**MOORE PUBLIC SCHOOLS -
HIGHLAND EAST JUNIOR HIGH SCHOOL
STEM ADDITION**

ADDENDUM NO. 1

January 26, 2022

SITE GRADING AND DETENTION

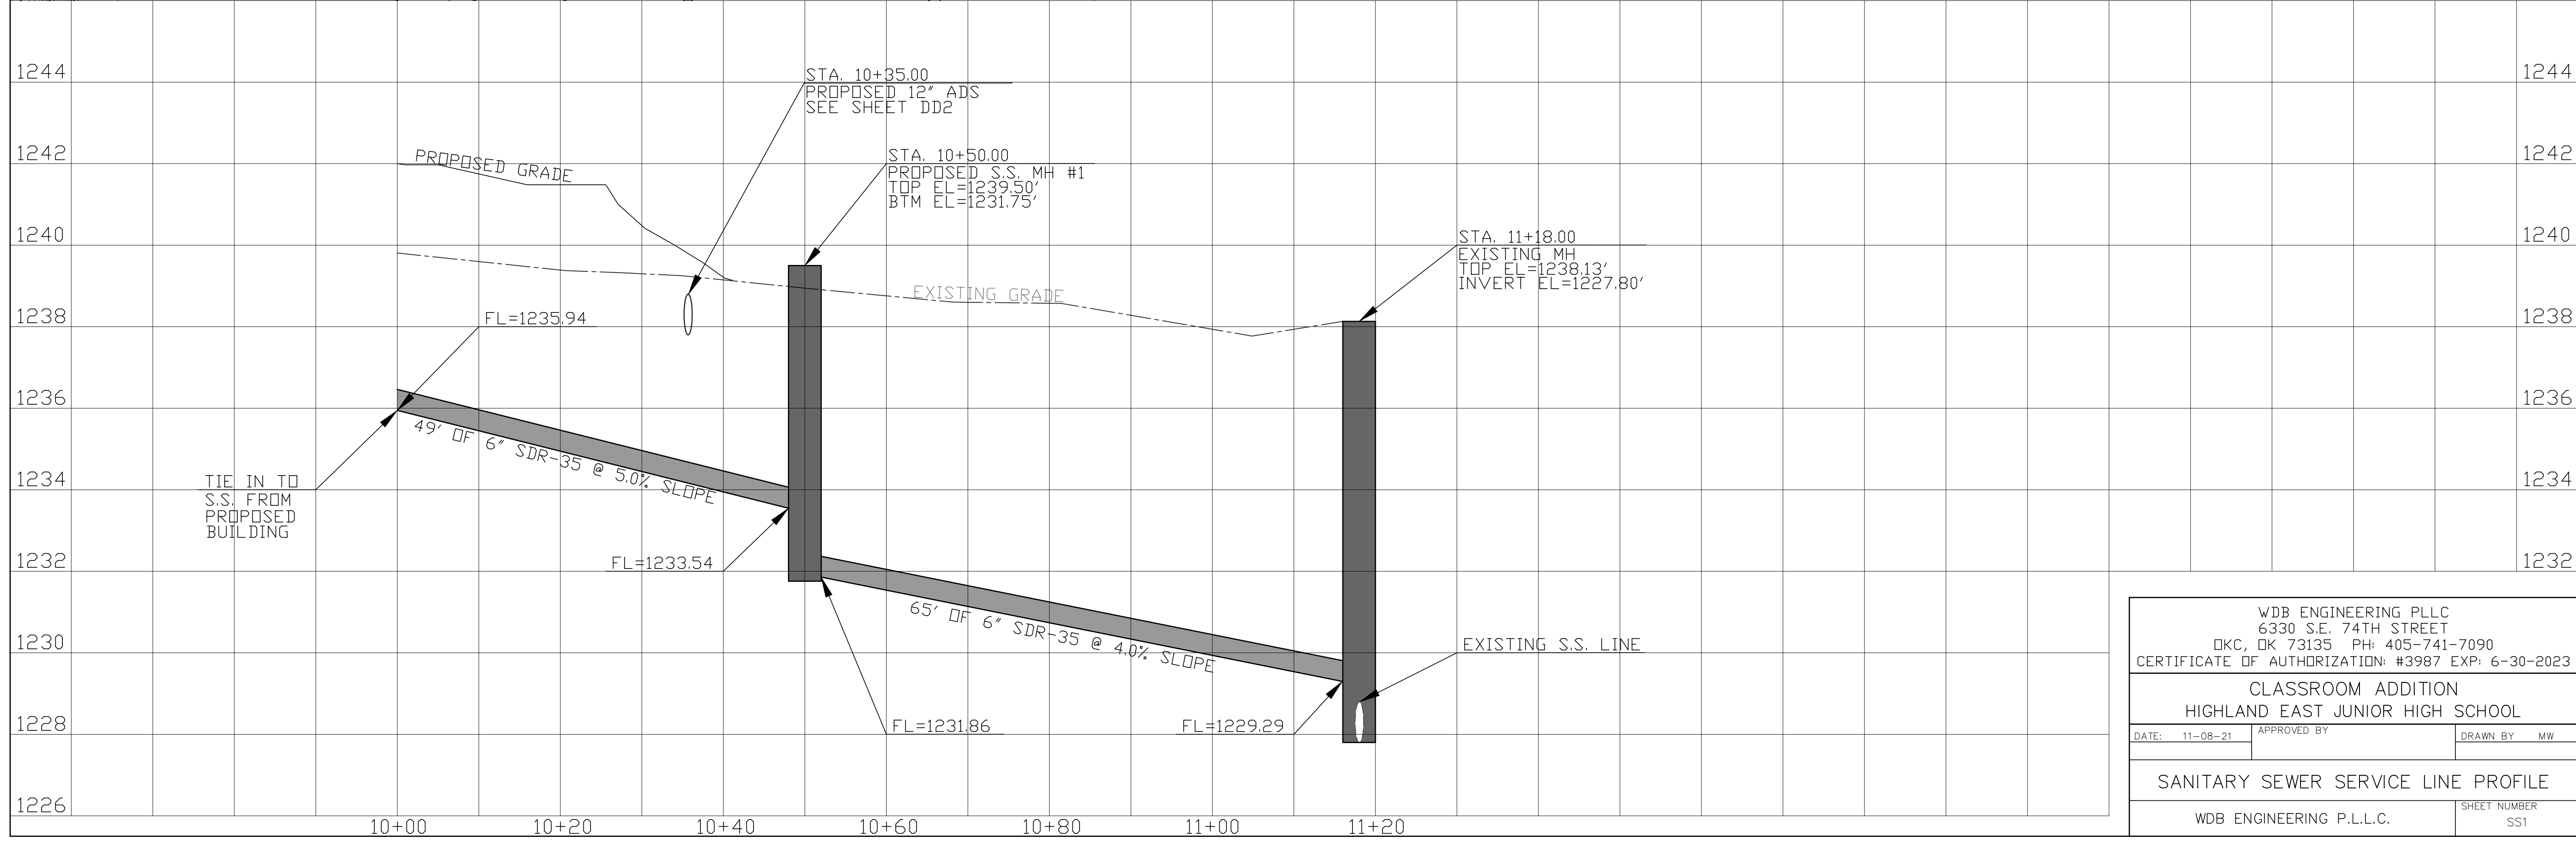
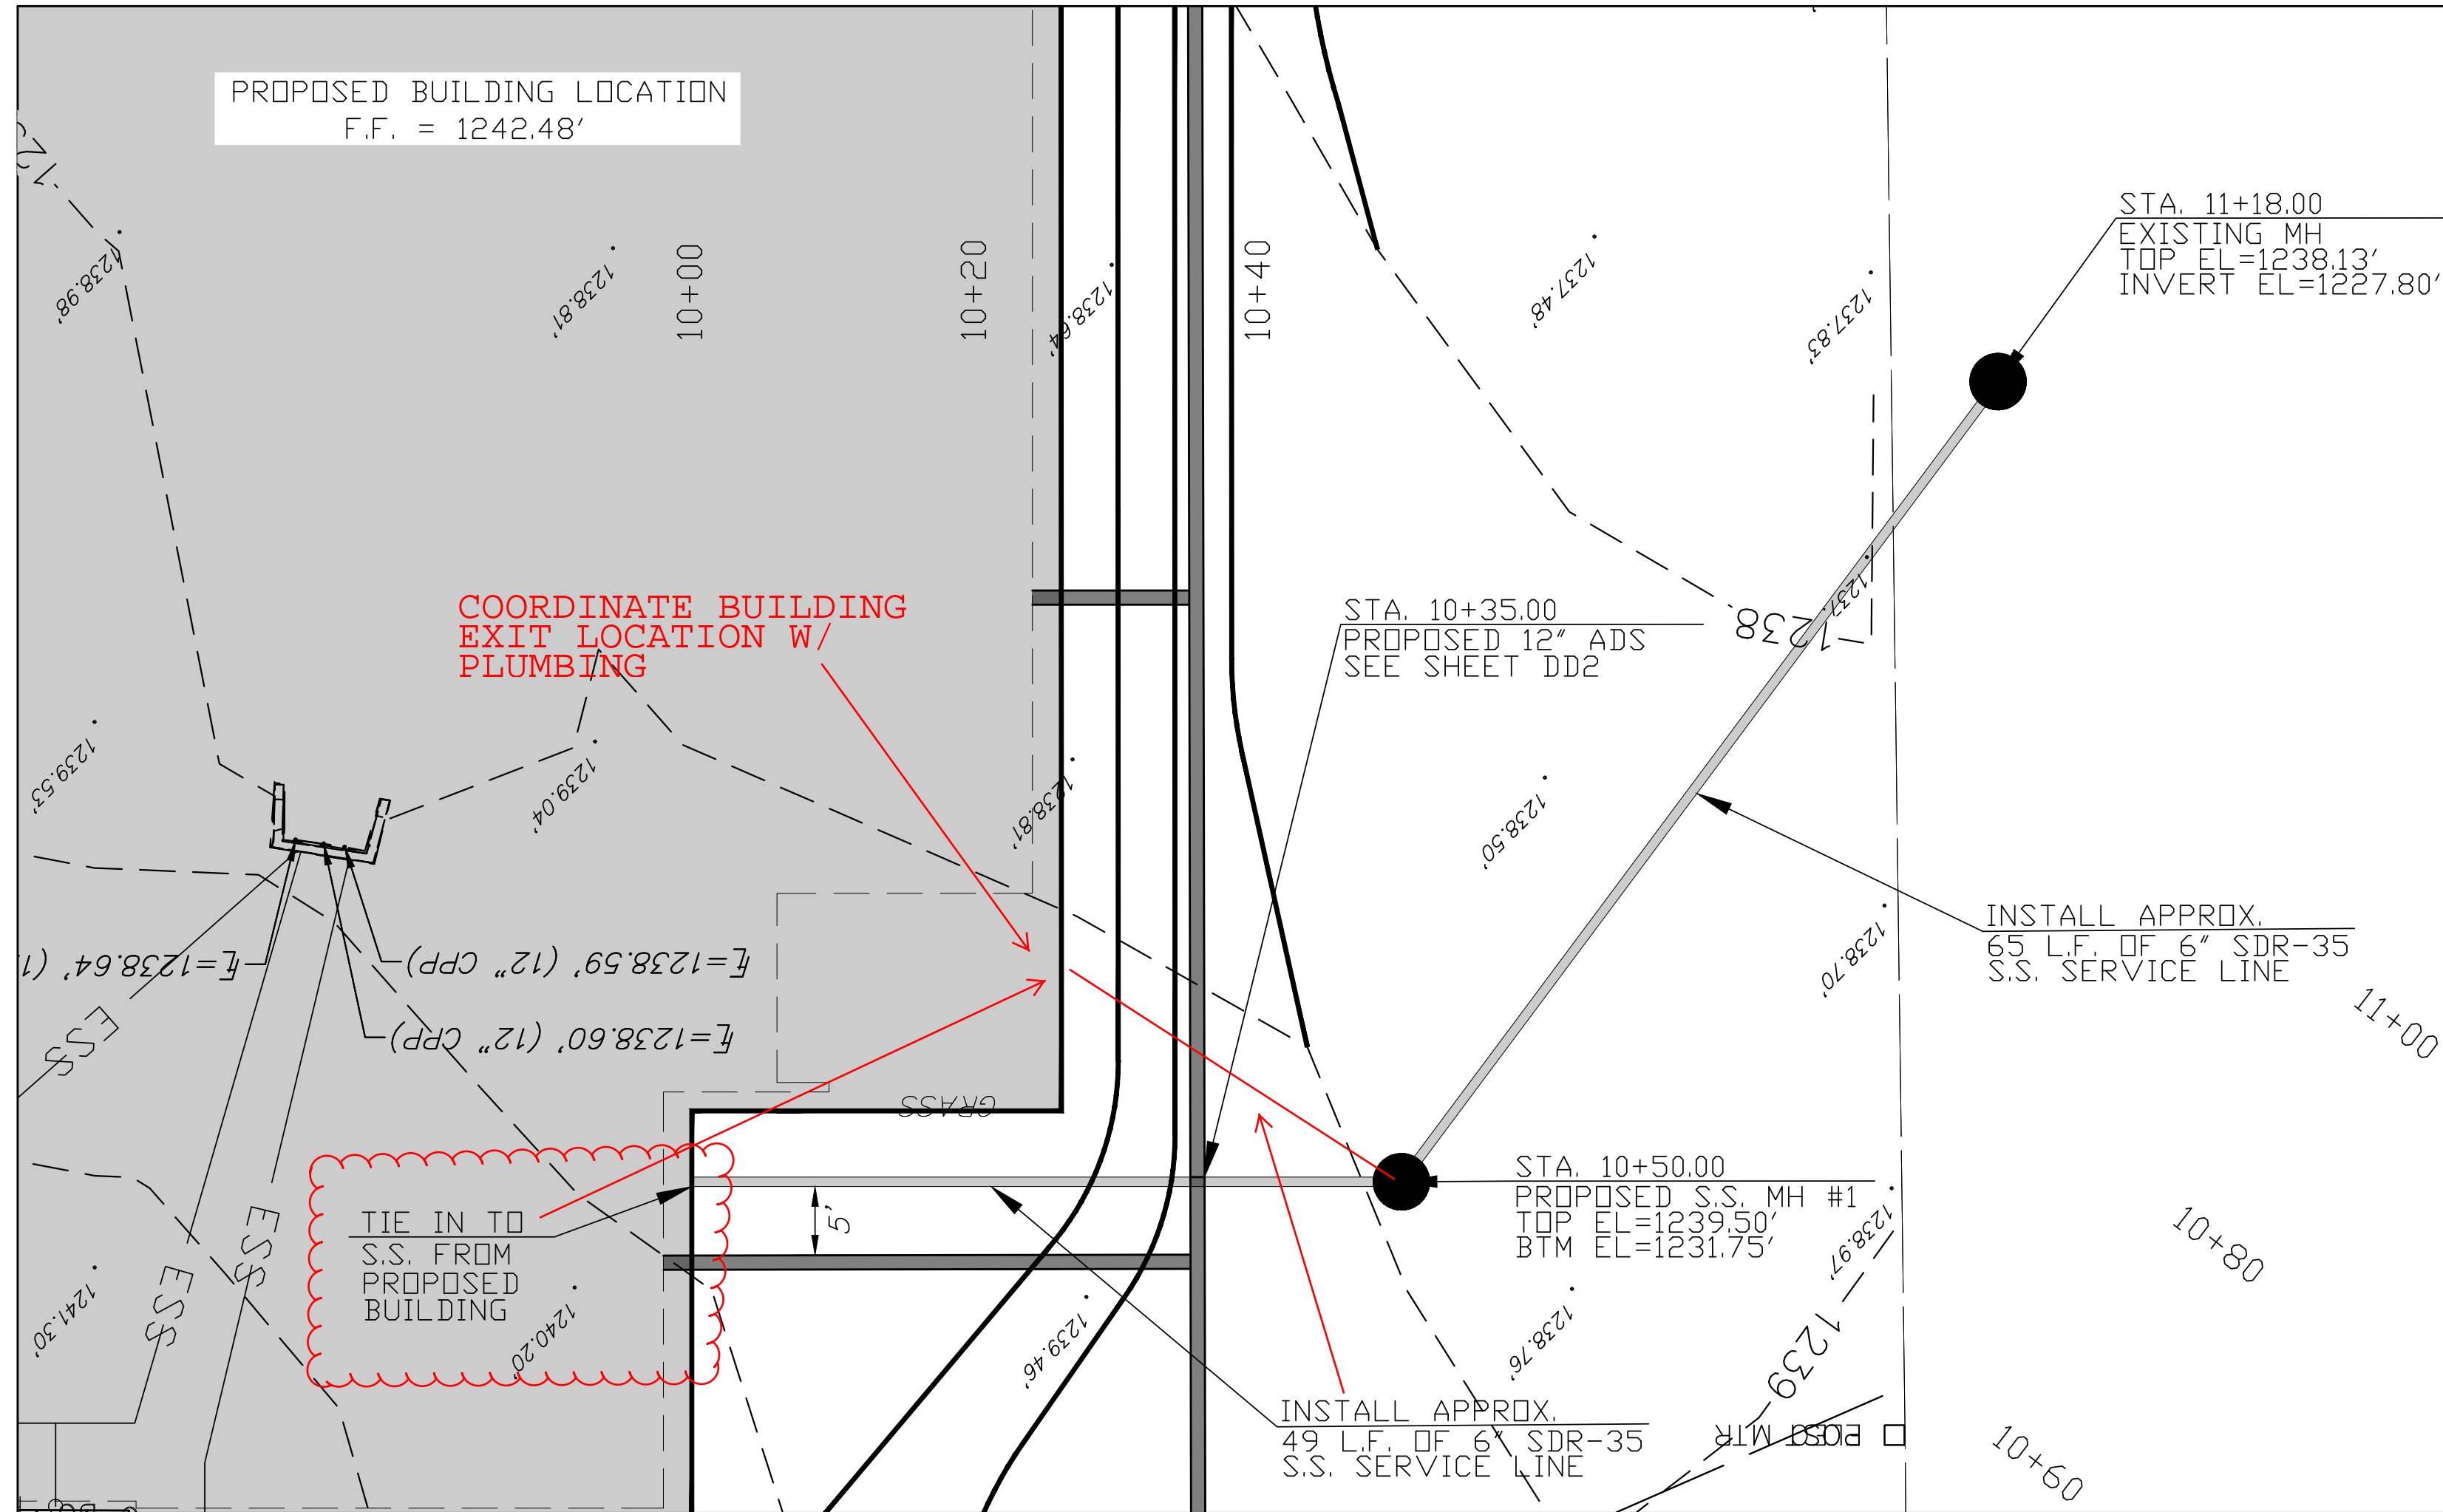
1. Sheet DD1, Site Grading and Detention: added plumbing coordination note at the northwest corner of the building. Refer to attachment.
2. Sheet SS1, Sanitary Sewer Service Line Profile: added plumbing coordination note at the northwest corner of the building. Refer to attachment.
3. Sheet C300, Detail #1, Paving Site Plan: revise sidewalk / mow strip locations as per attached revised drawing.
4. Sheet C600, Detail #1, Erosion Control Site Plan: locate construction lay-down area as per attached revised drawing.
5. Sheet C601, Detail #1, Laydown / Gravel Site Plan: locate and detail construction lay-down area as per attached revised drawing.

1 FLOOR PLAN
1/8" = 1'-0" 21,582 SQ. FT.

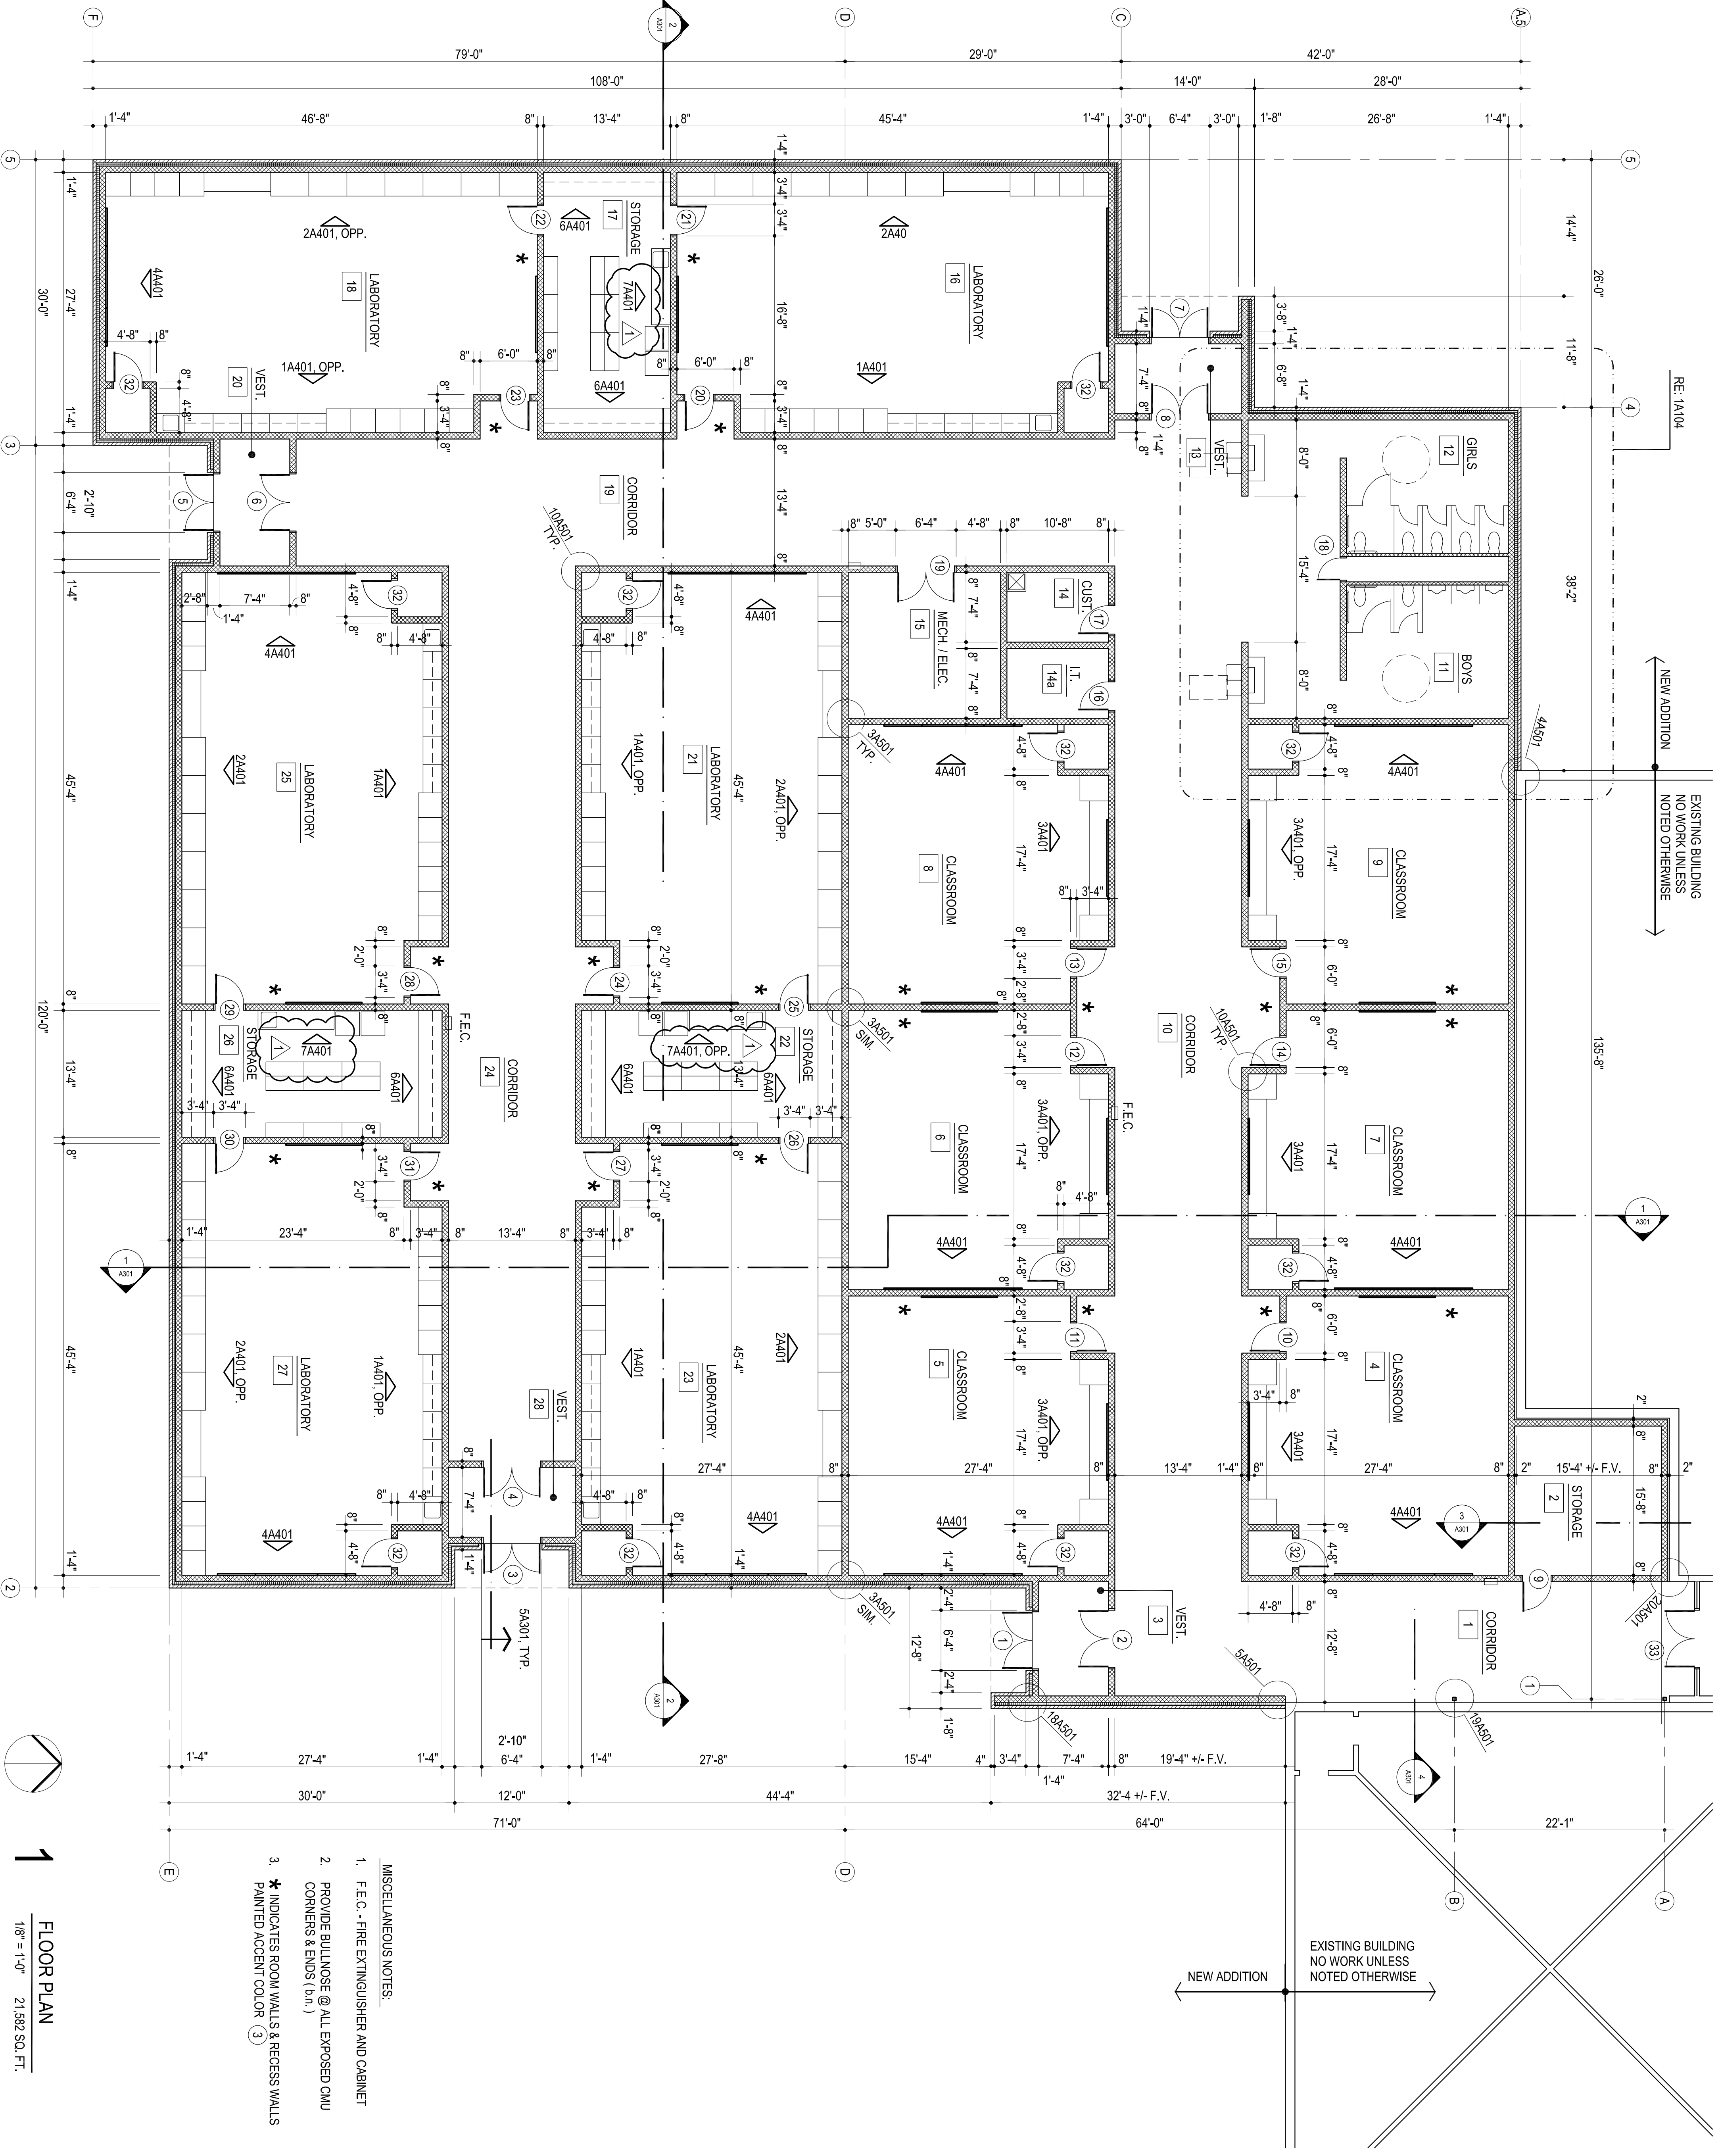
1. Sheet A103, Detail #1, Floor Plan: revise interior elevation referencing in Rooms #17, 22, and 26 as per attached revised drawing.
2. Sheet A401, Detail #2, Elevation at Typical Lab: revised number of equal spaces for shelving to "7 spaces" in lieu of six as indicated. Refer to attachment.
3. Sheet A501, Detail #20, Plan Detail and Sheet 601, Detail #2, Color Schedule: refer to attached Request for Information #2 for clarifications.
